COMMENTS RE: SIXPLEX CITY-WIDE STUDY

extending multiplexes from fourplexes to sixplexes

INTRODUCTION

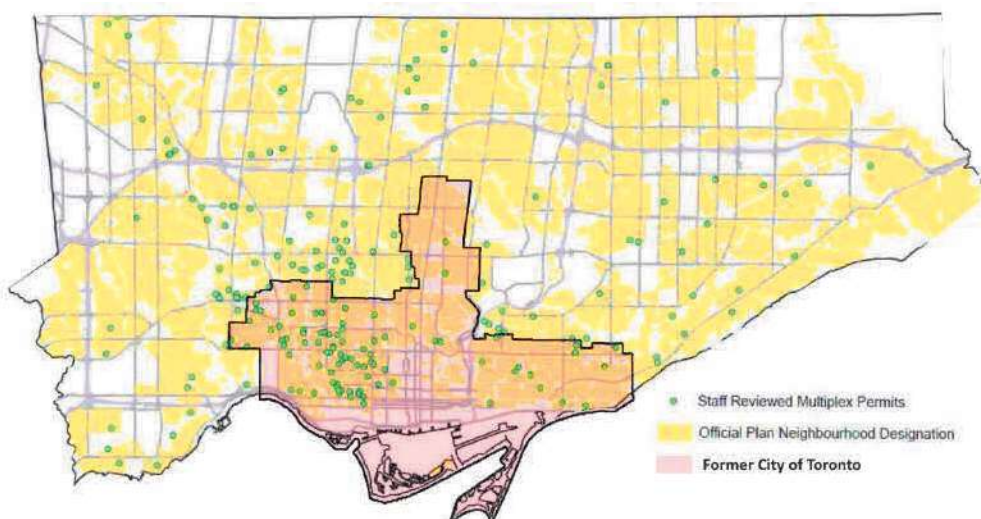
Almost half (46%) of all the lots in the former city are 6.1m (20ft) wide or less. One unit per floor, plus a secondary suite would be most appropriate while accommodating the associated facilities, amenities and OBC standards for multiplexes. A further 35% of all the lots in the former city are 9.14m (30ft) wide or less. The widths involved are still too narrow to accommodate more than one unit 'per building face per floor'. Bachelor units may be mixed with larger units, but subletting a second bedroom within a unit may be a more feasible and desirable.

The remaining 19% of inner-city lots are wide enough to accommodate side-by-side units per floor. This last category is truly the Six-plex's domain.

LAWRENCE AVENUE TODAY - WITH SIDEWALK AT CURB

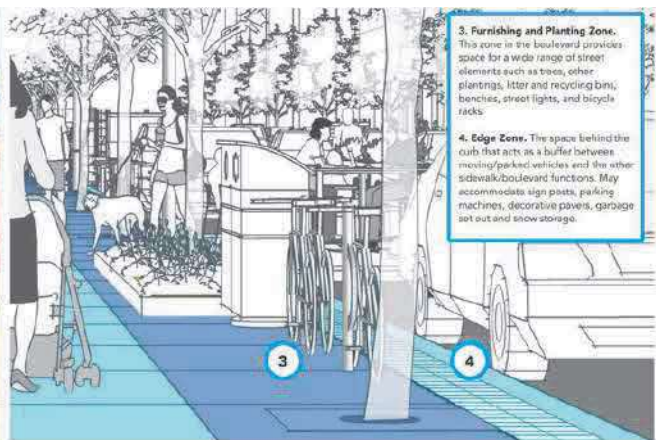
The photo below shows the south sidewalk immediately abutting the curb. The telephone pole in the middle of the footpath confirms that the road was widening after the pole was installed, as was typical practice at the time. The overall distance between the curb and the property line is 4.9m. Meanwhile, the diagram below and to the right shows a verge, setting the sidewalk back from the curb, and the separation accommodating trees, plantings, bicycle racks, waste containers and pavers.

The primary reason for relocating the footpath back from the curb is because the juxtaposition of pedestrians immediately next to the curb on a thoroughfare is not a safe proposition.

To accomplish the sidewalk relocation requires an incremental strategy, where each development, as it occurs, adopts the street plan and contributes towards the cost, on the understanding that the reconfiguration will occur on a block-by-block or part-by-part basis. This is similar to how, for instance, Roehampton's sidewalks and landscaping have evolved, and continue to evolve.
